World Forum for Harmonization of Vehicle Regulations

Working Party on Lighting and Light Signalling (GRE)

Proposal for Supplement 17 to the 00 series of amendments to Regulation No. 4 (Devices for the illumination of rear registration plates)

Submitted by the expert from Germany*

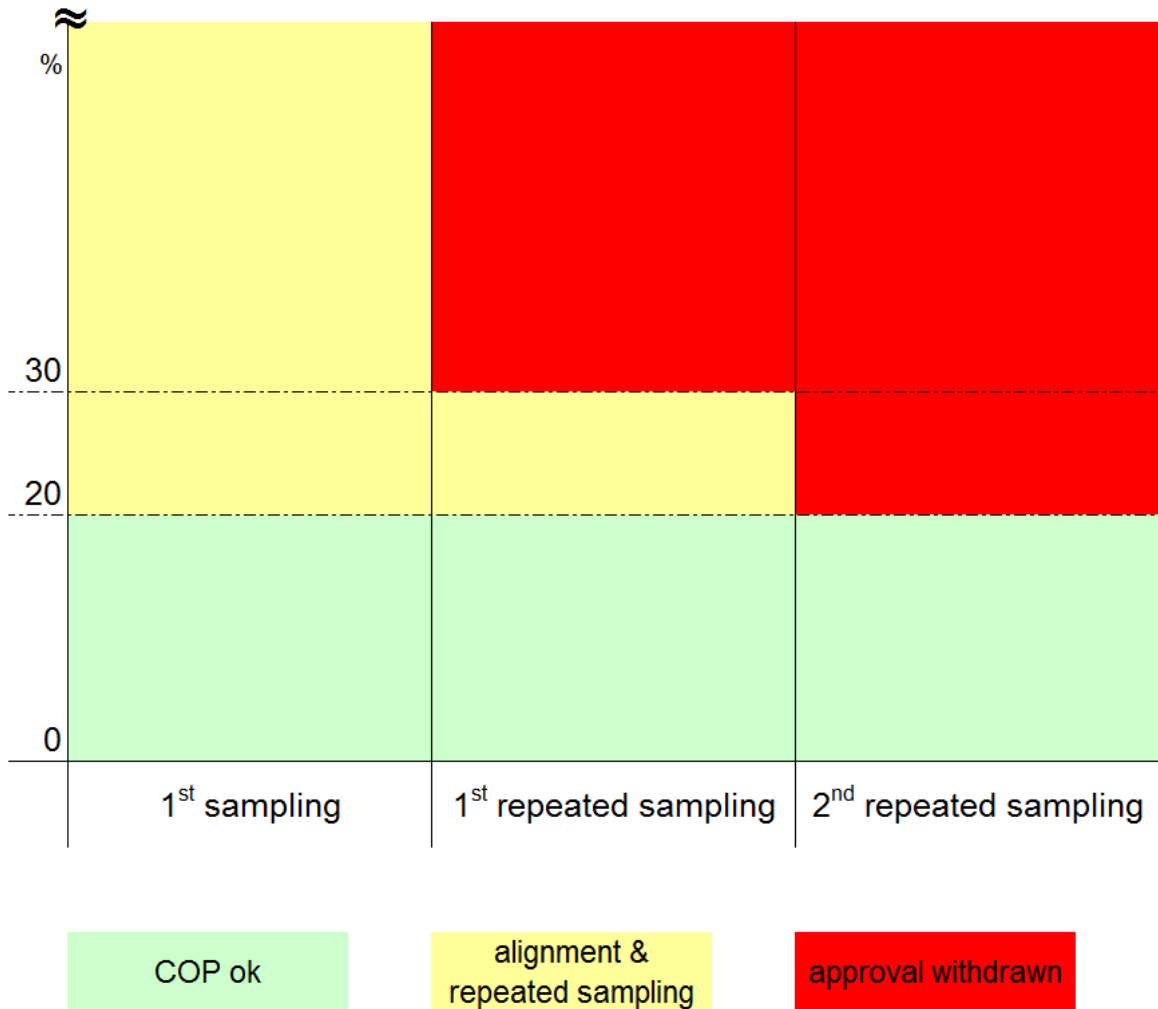
6. CoP is now described in a clear structured stepwise process (with limited steps), which gives the manufacturer the chance in the first step - in the case of deviations of more

than 20 per cent - to align his production process. Also, the CoP process can be completed earlier when the first two samples are in the full specifications.

7. The proposal details the "third step" which defines the condition where the approval shall be withdrawn, when after the second repetition of this process the manufacturer was not in the position to "align" his production process in the correct way.

8. The attached drawing shall demonstrate this stepwise process.
